File Number: 5-C-25-DT

**Meeting:** 5/21/2025  
**Applicant:** Justin Hare MHM Architects  
**Owner:** YWCA Knoxville  
**Project:** YWCA

**Location:** 420 Clinch Ave. **Parcel ID:** 94 L G 010  
**Zoning:** DK-G (Downtown Knoxville, Grid)  
**Description:**  
YWCA window replacement.

<b>DESIGN REVIEW BOARD</b>	<b>5-C-25-DT</b>		Petitioner: Justin Hare    MHM Architects
	<b>APPLICATION FOR CERTIFICATE OF APPROPRIATENESS</b>		
		420 Clinch Ave. <b>Level 2: Major alteration of an existing building/structure</b>	
Original Print Date: 5/7/2025      Revised:		  <b>Feet</b>	
Knoxville/Knox County Planning · Design Review Board

**A302**  
EAST & SOUTH  
ELEVATIONS  
Copyright © 2021 McCarthy Holtsapple McCarthy

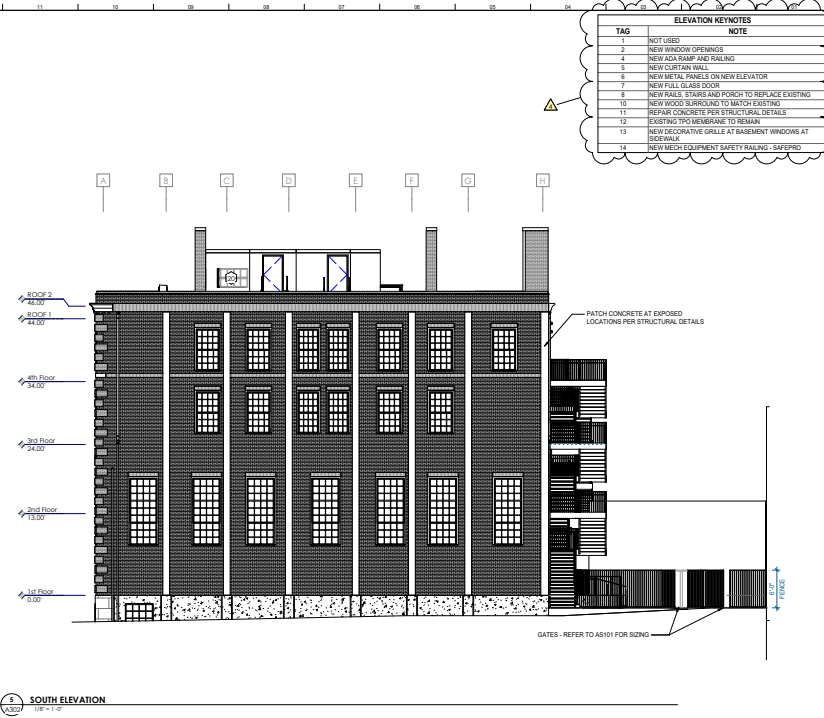
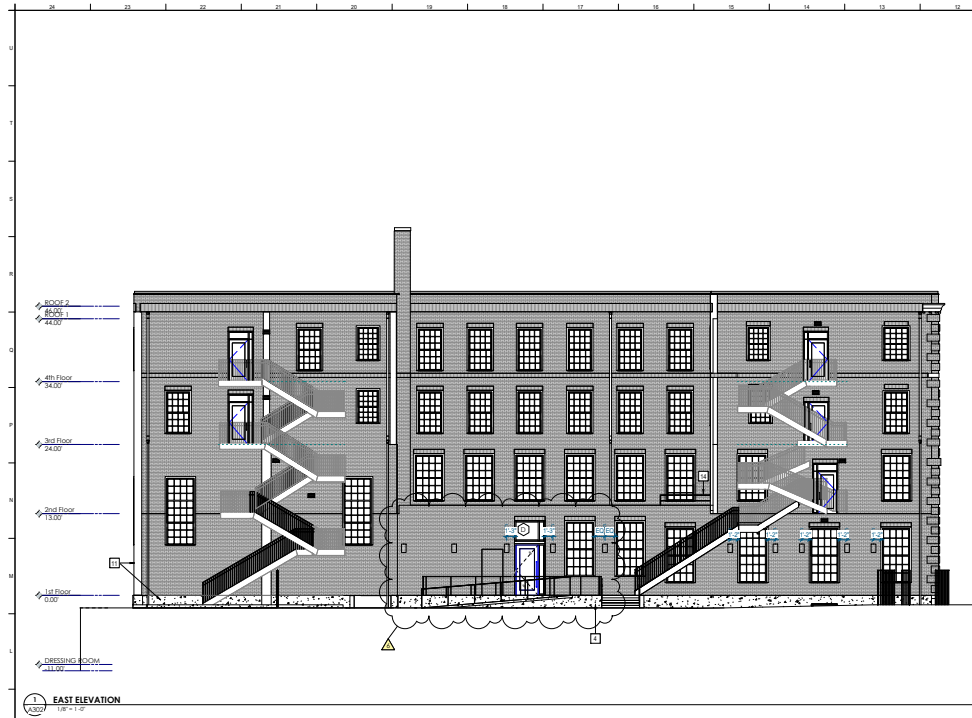
The proposed double-hung aluminum-clad wood windows with a black exterior finish and simulated divided lights are a compatible replacement, although they do not fully replicate the color, material, and operation type of all of the windows. The application intends to replicate the existing multi-pane patterns, though the elevation drawings do not accurately reflect all of the existing window profiles, in particular showing 12/12 profiles as opposed to the existing 12/16 profiles on the main level of the primary elevations. If the intent is to replicate the exact profiles, the elevation drawings or a separate window schedule should indicate the individual window arrangements to be used. It may not be feasible to replicate the exact patterns of the steel awning windows on the secondary elevations, but all efforts should be taken to replicate the patterns on the primary (Clinch Ave and Walnut St) elevations.

The proposed windows will be the same size as the originals, but they will feature a deeper jamb. The existing brick window openings, sills, trim, lintels, and keystones should be retained and repaired as necessary.

Staff recommends approval of Certificate 5-C-25-DT, subject to the following conditions: 1) elevation drawings or window schedule to accurately depict the multi-pane window arrangements to be replicated; 2) the existing brick window openings, sills, trim, lintels, and keystones to be retained and repaired as necessary.
